R23CK

IMPORTANT SAFETY RECALL

NHTSA Recall Number: 24V-758 School Bus
NHTSA Recall Number: 24V-759 Non-School Bus

SUBJECT: R23CK: FMVSS 217 Noncompliance - Rear and Side Emergency Exit Label Inaccurate Font Size

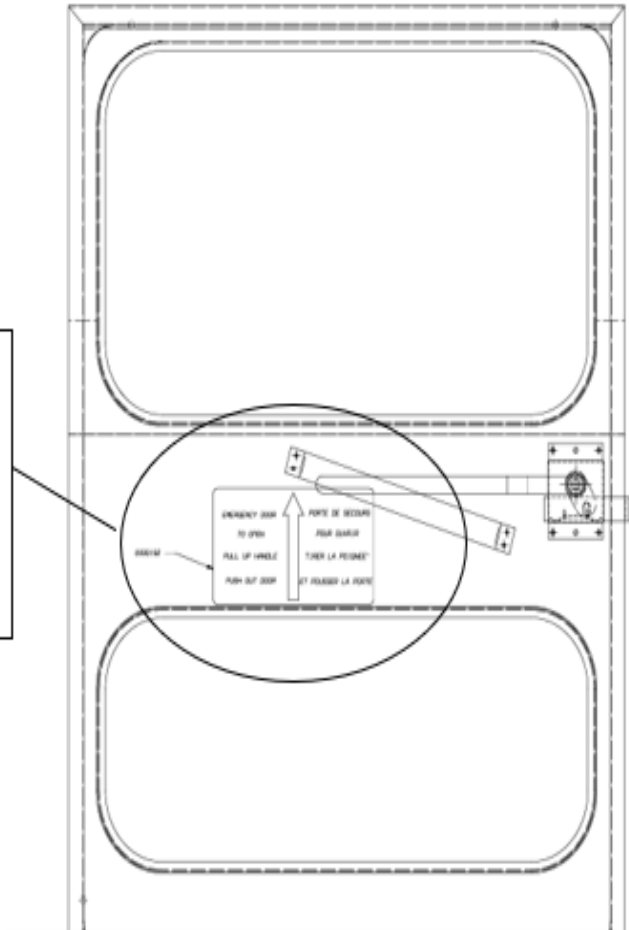
On the subject buses, it has been determined certain Blue Bird Vision (BBCV) and All American (T3FE/T3RE) School Bus and Non-School Buses fail to comply with FMVSS 217, Bus Emergency Exits and Window Retention and Release. The Emergency Exit Label requirements for the operating instructions letter height is non-compliant. The requirement specifies the instructions describing the motions necessary to unlatch and open the emergency exit. The instructions shall be in letters at least 1 centimeter high and of a color that contrasts with its background. The letters measured was 0.88 centimeters. The Emergency Exit Label Operating Instructions do not meet the minimum letter height requirement of 1 centimeter.

To correct this condition, all affected vehicles will need to be updated with the latest label appropriate 1 centimeter high letters and of a color that contrasts with its background.

Instructions to install new decal over old decal

1. Locate decals at RED & SED exits
2. Clean surface of old decal with alcohol
3. Wait 5-10 seconds for area to dry
4. Install new decal directly over old decal
